HISTORIC AND DESIGN REVIEW COMMISSION

February 03, 2021

HDRC CASE NO: 2021-045
ADDRESS: 317 E MYRTLE
LEGAL DESCRIPTION: NCB 1746 BLK 001 LOT 5 & E 25 FT OF 4
ZONING: MF-33, H
CITY COUNCIL DIST.: 1
DISTRICT: Tobin Hill Historic District
APPLICANT: ARMENDARIZ CHERYL KATHLEEN M & RICHARD ANTHONY
OWNER: ARMENDARIZ CHERYL KATHLEEN M & RICHARD ANTHONY
TYPE OF WORK: Installation of window screens, amend window replacement on rear structure
APPLICATION RECEIVED: January 13, 2021
60-DAY REVIEW: Not applicable due to City Council Emergency Orders
CASE MANAGER: Huy Pham

The applicant is requesting a Certificate of Appropriateness to amend the previous window replacement plan from 9 wood windows and 5 aluminum windows so all 14 aluminum window with wood screens.

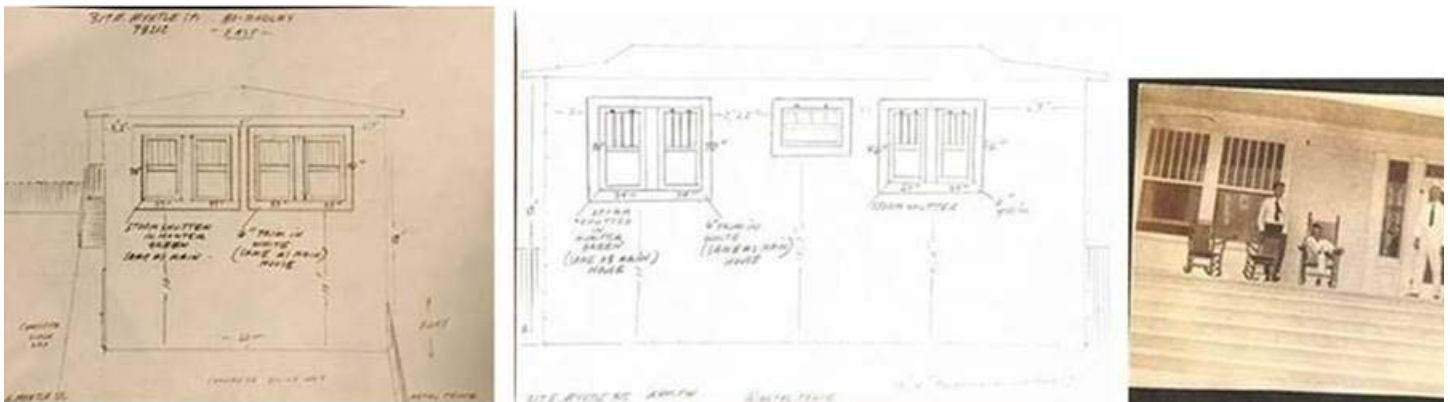
Original photo in 1920's of our main house showing the shutter design. We would replicate this look exactly.

Structure showing original shutter design we want to recreate on all 4 sides.

Staff does not recommend approval to amend the allowance of replacing and additional 9 wood windows with aluminum windows based on the findings. Staff finds that the proposed windows screens are appropriate in addition to, but not in lieu of, window restoration.

317 E. MYRTLE ST. 80-RADLEY
78212 - EAST -

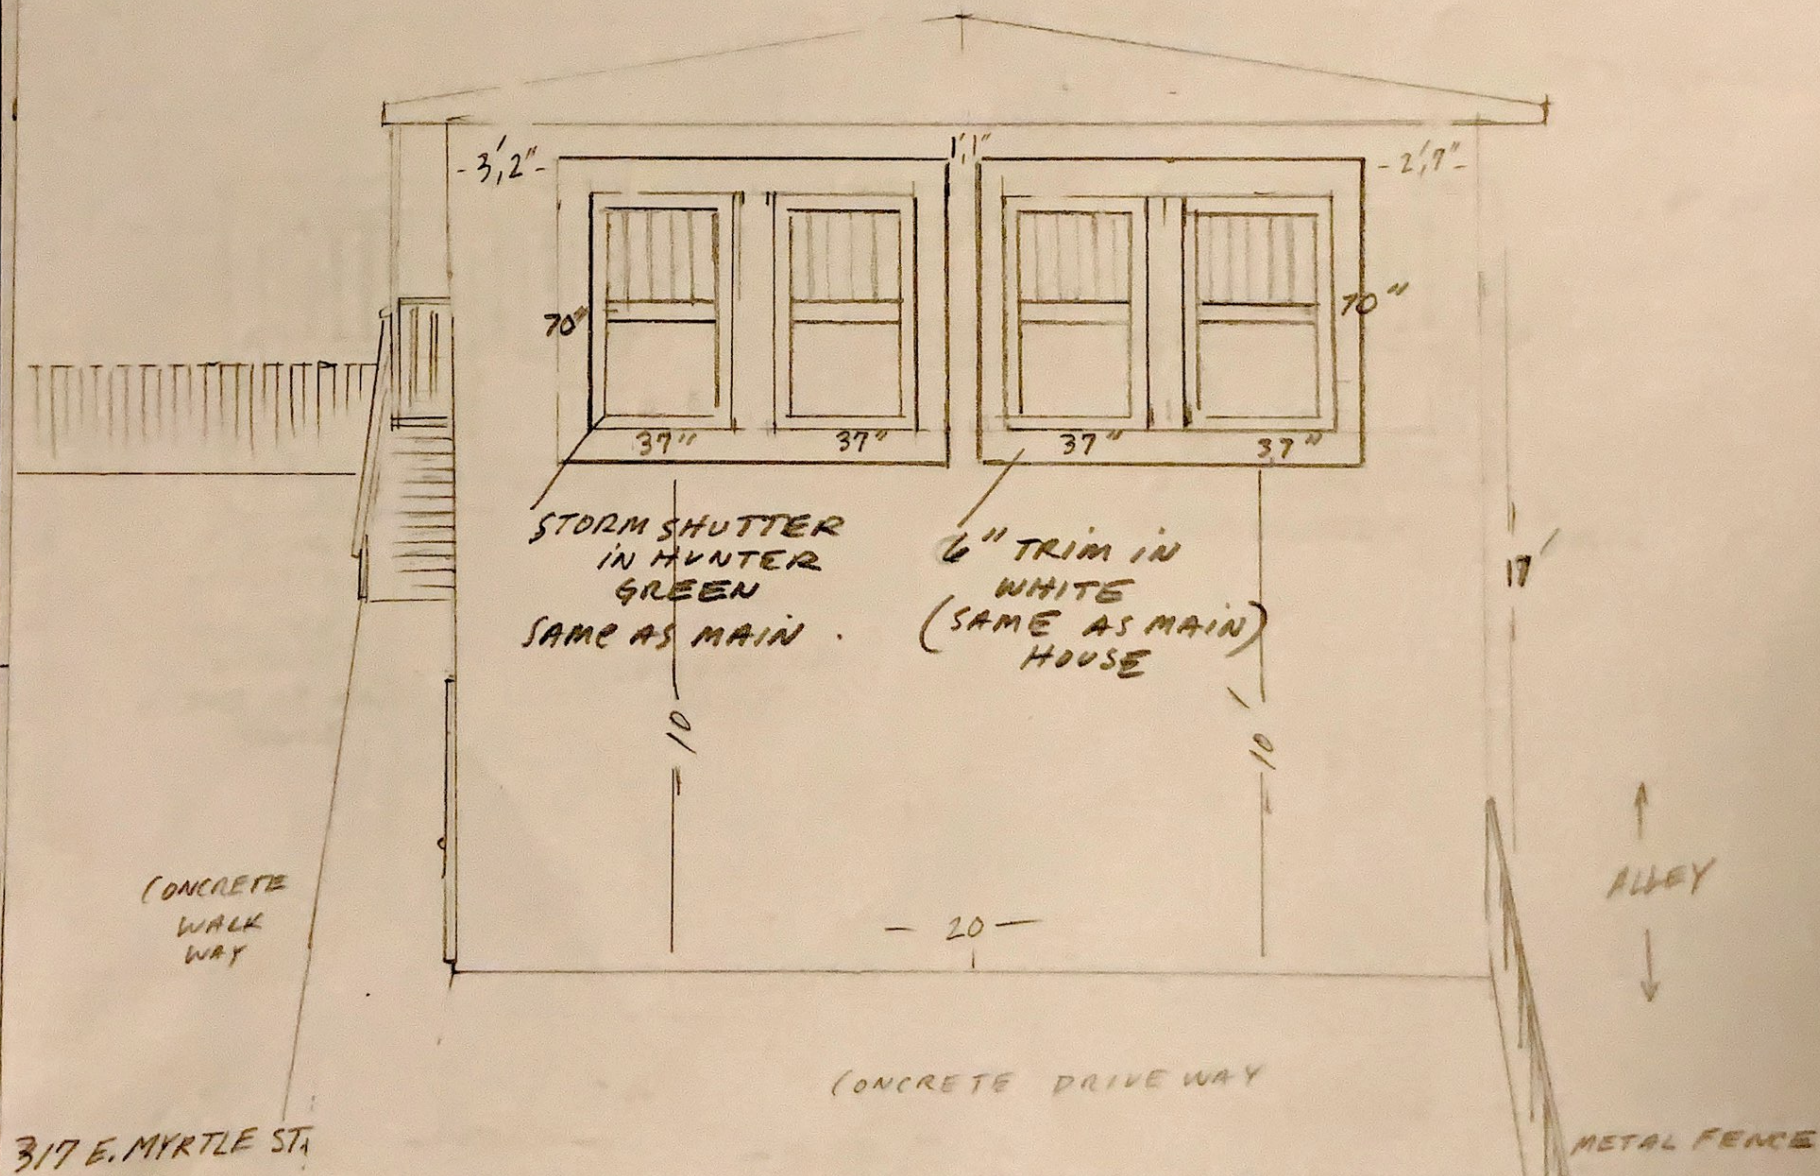
Replacement Option. With the current new windows in place, we are proposing to add storm shutters and an additional 6" wood trim down the center, that will echo the 6" wood trim around entire window. This will replicate the original look of structure from 1914 and would cover up any visual view of new vinyl window. *Pls see below drawings.* The added wood shutters will showcase a more authentic historic look than just replacing windows on two sides, as approved by the board already.

317 E. MYRTLE ST.
78212BO RADLEY
- NORTH -

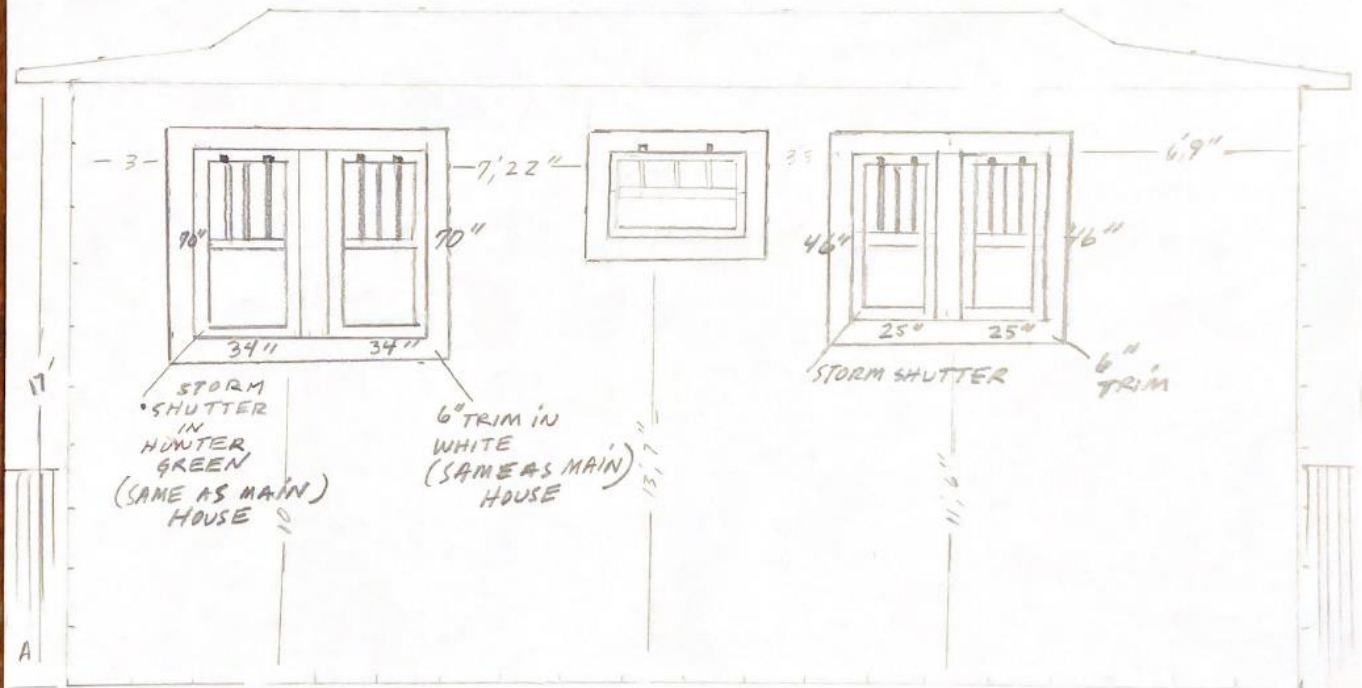
15' 4" TOP PART OF ALL WINDOWS
